Access Compliance Report

Public Rights-of-Way

(Curb Ramps)

Intersection ID: 15205	Main Street: CHEROKEE_RD	Cross Street: FENTON_PL	Location: S
ADA ID: B6B0EC0D649C	Ramp Type: BlendTrans2	Initial Pass/Fail: Pass	Overall Compliance: No
Severity Score: 2.75			
Codes/Mitigation Info/Possible Solution		Field Measurements/Component Compliance

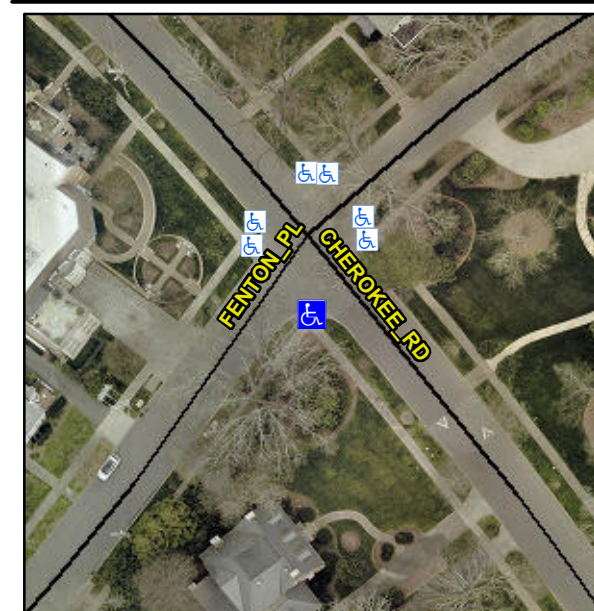
Not Found, R304.5.3, R305.1.4, R305.2

Compliance	Description	Data	Compliance	Description	Data
N/A	Ramp Length (in)	84.0	Yes	BlendTrans Slope (%)	3.0
Yes	Ramp Width (in)	94.0	No	BlendTrans XSlope (%)	3.3
N/A	Flare Type LT	Sloped	N/A	Flare Type RT	Sloped
N/A	Flare Slope LT (%)	N/A	N/A	Flare Slope RT (%)	N/A
N/A	Flare Traversable LT?	No	N/A	Flare Traversable RT?	No
N/A	Landing Length (in)	N/A	Yes	DWS Provided?	Yes
N/A	Landing Width (in)	N/A	Yes	DWS Contrast?	Yes
N/A	Landing Slope (%)	N/A	Yes	DWS Length (in)	24.0
N/A	Landing X Slope (%)	N/A	No	DWS Full Width?	No
N/A	Landing Curb? (Y/N)	No	No	DWS Offset (in)	3.0
N/A	Shared Landing?	No			
Yes	Gutter Ponding?	No	Yes	Gutter Slope (%)	3.8
Yes	Gutter Lip Ht (in)	0.0	No	Gutter X Slope (%)	3.4
N/A	Painted X Walk1?	No	N/A	Painted X Walk2?	No
	X Walk 1 Direction	To NE		X Walk 2 Direction	To NW
	X Walk 1 Width (in)	N/A		X Walk 2 Width (in)	N/A
	X Walk 1 Slope (%)	0.2		X Walk 2 Slope (%)	3.4
	X Walk 1 X Slope (%)	5.3		X Walk 2 X Slope (%)	1.7

N/A	Ramp inside XWalk1?	N/A	N/A	Ramp inside XWalk2?	N/A
	Road Slope (%)	2.7		Clear Space?	Yes
	Road X Slope (%)	4.9	N/A	Clear Space to XWalk (in)	N/A
Yes	Any Obstructions?	No	Yes	Storm Grate/Utility Hazard?	No
	Obstruction Type			Storm Grate/Utility Type	
		N/A			N/A
			Yes	Surface Condition? (G/P)	Good
			No	Curb Slope (%)	15.6

Remove & Replace Curb Ramp With Two New Directional Ramps or Equivalent. Remove & Replace Gutter.
